# Conceptual Review Agenda

Schedule for 04/14/14 to 04/14/14

**Re:** 300 Hickory St - Light Industrial/Retail

**Re:** 2111 Custer Dr - Dental Office

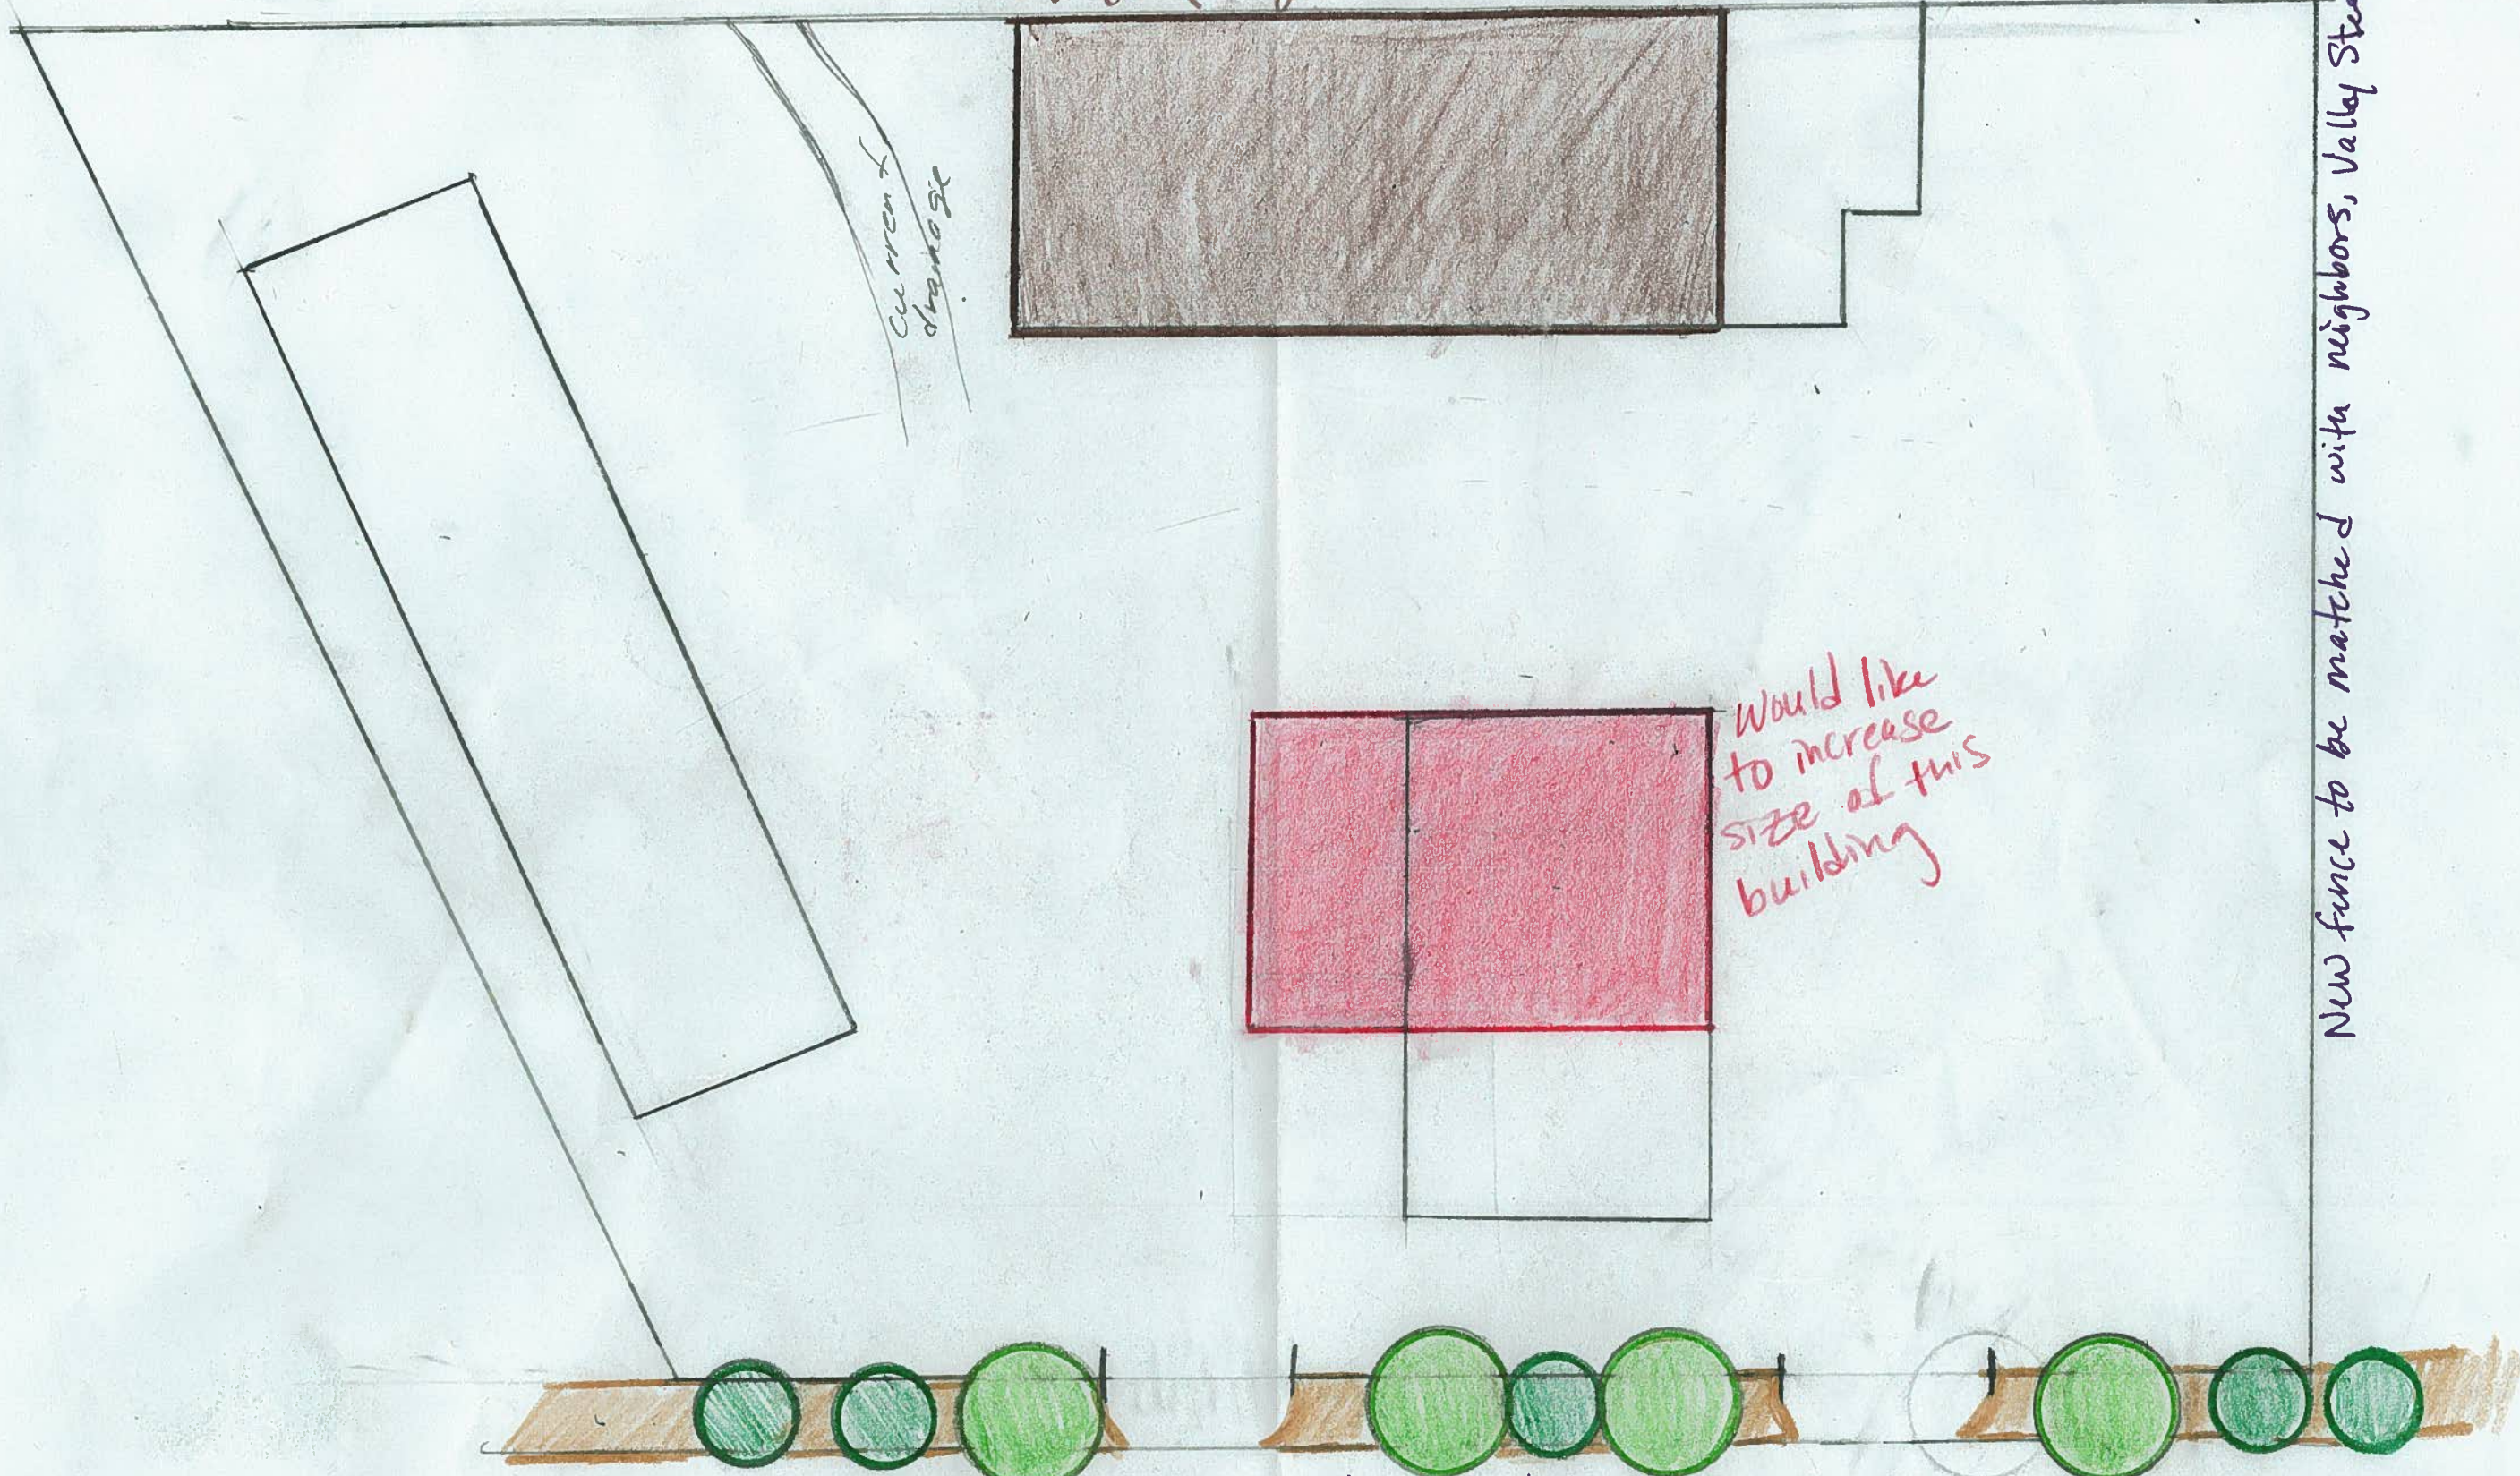
1. It is important to document the existing impervious area since drainage requirements and fees are based on new impervious area. An exhibit showing the existing and proposed impervious areas with a table summarizing the areas is required prior to the time fees are calculated for each building permit.

2. Since the existing buildings are to remain, a drainage letter should be sufficient to document the existing drainage patterns and to discuss the water quality measures being provided. The drainage letter needs to address the four-step process for selecting structural BMPs. Also standard operating procedures (SOPs) must be prepared for each of the BMPs being used on the site. They must be prepared by a Professional Engineer registered in Colorado.

6. The drainage engineer will need to identify the drainage outfall for the since we have no documentation on where the water goes when it leaves the site. It might drain to the east in Hickory St. As long as there is not an increase in impervious area the present outfall can be used unless it has problems and needs some improvements to meet present standards.

6. This project is responsible for dedicating any right-of-way and easements that are necessary for this project. Right-of-way along Hickory Street to meet the collector standard will need to be dedicated and provided with the project. This will likely require the fence to be relocated.

**Description of Proposal** (attach additional sheets if necessary) SEE ATTACHED SITE PLAN.

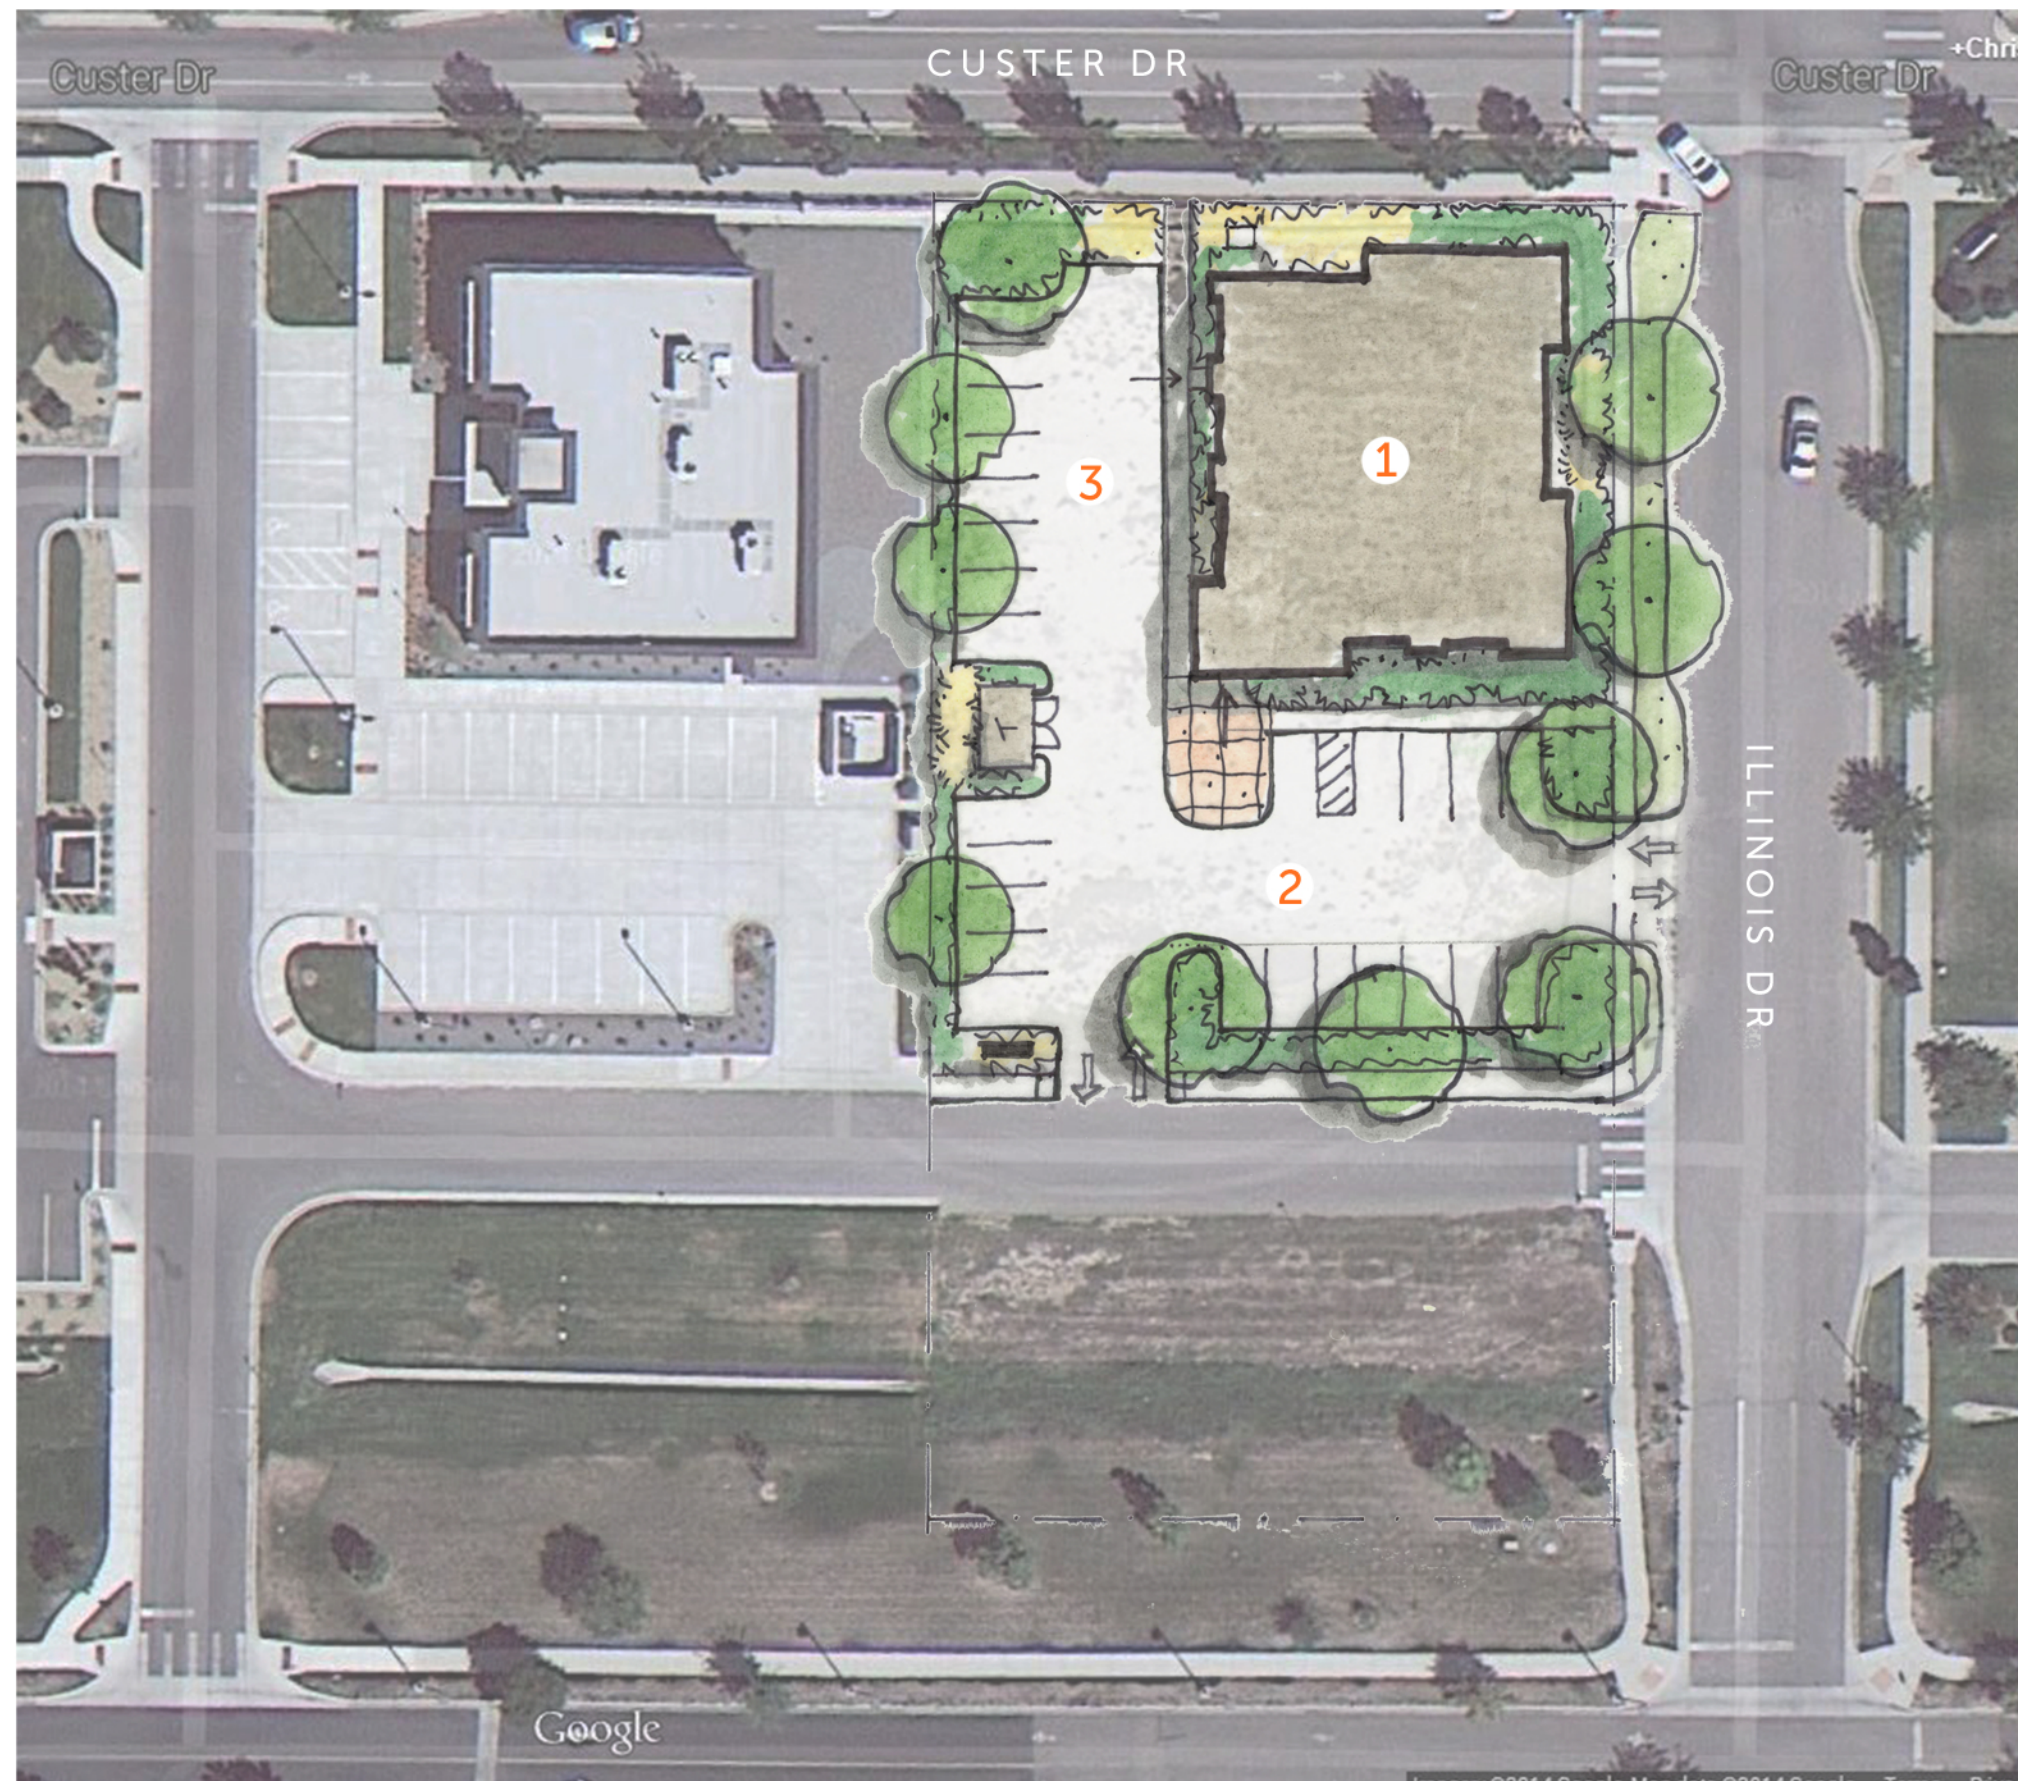
1. The site plan shows 25 parking spaces. Sec. 3.2.2(K) limits the number of parking spaces for a medical office to a maximum of 4.5 spaces per thousand square feet of floor area. This means that no more than 22 parking spaces are allowed.
2. LUC 3.2.2(C)(b) Medical offices have a minimum bicycle parking requirement based on the square footage of 1/4,000 SQFT, minimum of 4 spaces, 20% of these would need to be enclosed, 80% would need to be fixed bicycle racks.
3. LUC 3.2.2(K)(5) Handicap parking spaces are required in numbers per this section, meaning 1 such space is required and it must be a van accessible space.
4. LUC 3.2.5 Please see this section for accessible trash and recycling enclosures requirements.
5. Offices and clinics are an Administrative (type I) review in the Neighborhood Commercial zone.

7. Utility plans will be required and a Development Agreement will be recorded once the project is finalized.
8. A Development Construction Permit (DCP) will need to be obtained prior to starting any work on the site.
9. All access to this parcel is to be off of the shared driveway. The additional access shown on the plan onto Illinois will not meet driveway separation requirements.

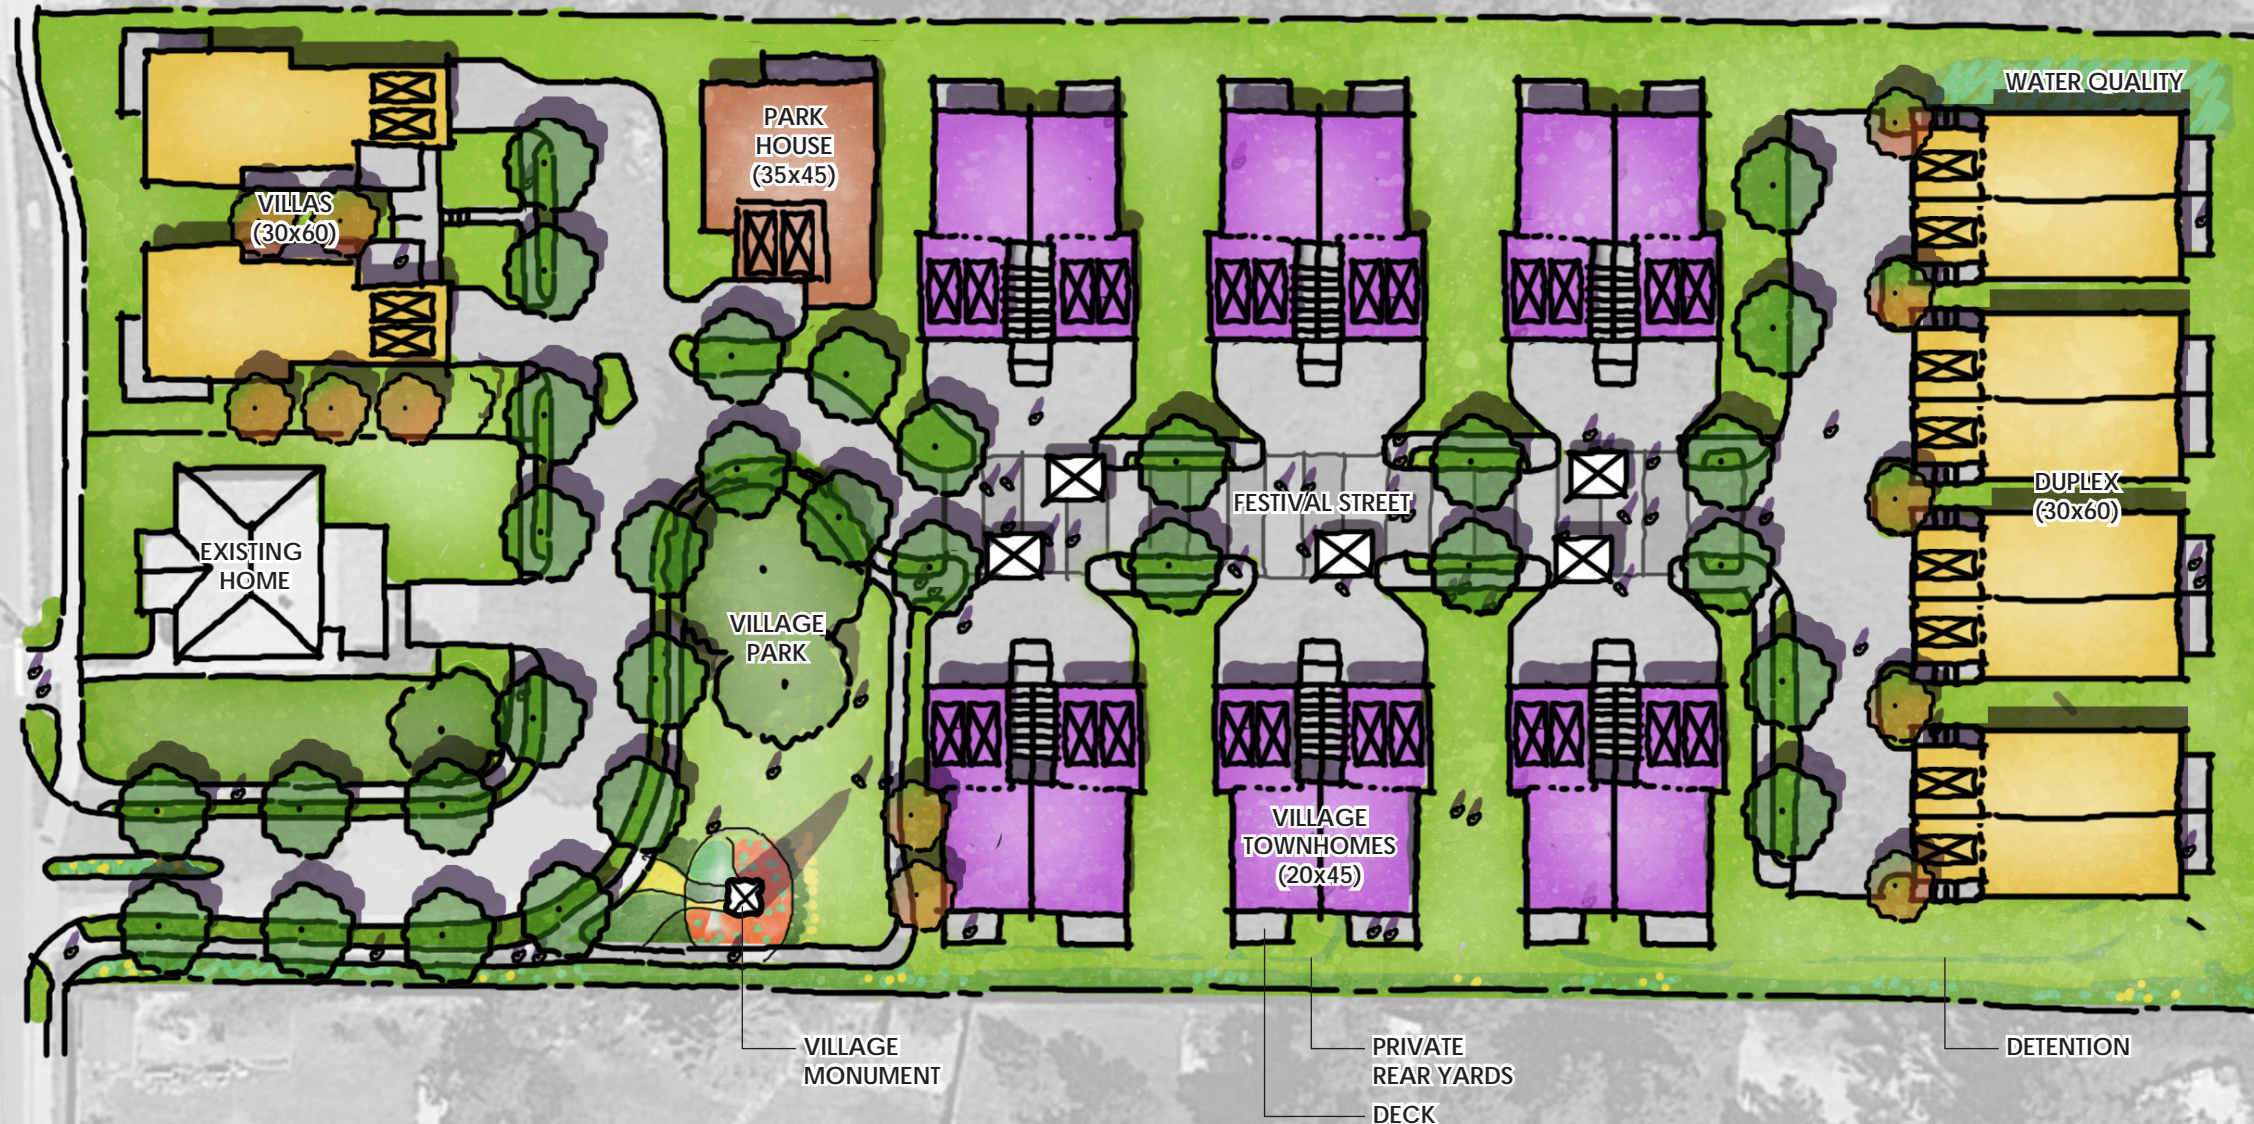
The private drive on this site must be designed to fire lane standards. The conceptual plan presented for review will require further consideration as minimum lane widths and turning radii may not meet the International Fire Code. An Emergency Access Easement shall be dedicated. Fire code references and specifications are provided for your reference.
